PRODUCT UPDATE

#183

2B 16-pin Female Insulator Modification

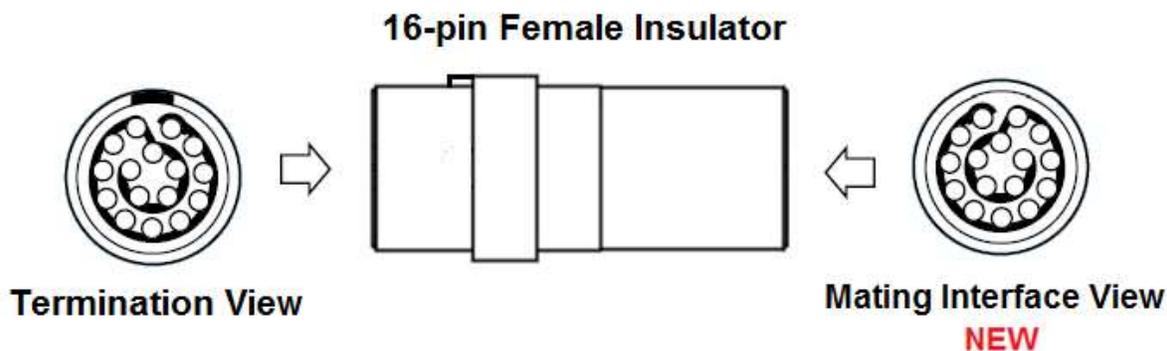
The 2B 16-pin female insulator has been slightly modified to provide visual identification of the pin numbering sequence. There is no change to form, fit or function.

A raised spiral has been added to the mating interface side of the female 2B 16-pin insulator as shown in the sketch below:

The change will be implemented when stock is depleted.
